UNITED STATES PATENT AND TRADEMARK OFFICE

APPLICATION NO.	FILING DATE	FIRST NAMED INVENTOR	ATTORNEY DOCKET NO.	CONFIRMATION NO.
10/722,645	11/26/2003	Carlton Plunk	ZK522/03051	7326
27868	7590	07/25/2005	EXAMINER	
JOHN F. SALAZAR MIDDLETON & REUTLINGER 2500 BROWN & WILLIAMSON TOWER LOUISVILLE, KY 40202			REHM, ADAM C	
			ART UNIT	PAPER NUMBER
			2875

Office Action Summary	Application No. 10/722,645	Applicant(s) PLUNK ET AL.	
	Examiner Adam C. Rehm	Art Unit 2875

DETAILED ACTION

Fig. 9

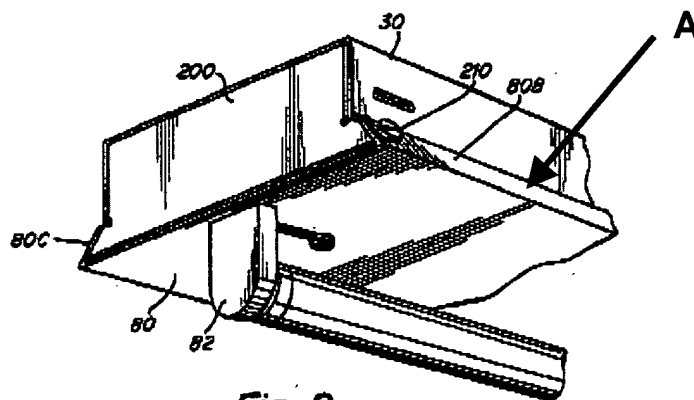
2. Claims 1-27 are rejected under 35 U.S.C. 102(b) as being anticipated by WEATHERS (US 6,210,019).
3. Regarding Claims 1-23 and 25-27, WEATHERS provides a retrofit unit for a fluorescent lighting fixture comprising a chamber (80A, Fig. 3) having:
 - An elongated protruding bottom wall with angled surfaces (Fig. 5 illustrates wall 80/80A/80B protruding outwardly from the fixture 30; see below Fig. 9, Ref A) for

enclosing an existing fluorescent strip light fixture (30) having an existing ballast (34);

- A retrofit ballast (90) with power leads/wiring (102/104) in the chamber's interior surface and affixed to said protruding bottom wall (Fig. 3);
- A plurality of opposing and downwardly extending lamp holders attached to the chamber's exterior surface, ballast and wiring (82/86);
- Two oppositely attached side walls forming the chamber and affixed to the bottom wall (80A/80B, see below Fig. 9, Ref. A);
- A plurality of mounting brackets removably attached to said retrofit chamber opposite said bottom side (202/204, Fig. 8); and
- A pair of opposing end caps removably attached to said side walls (200);
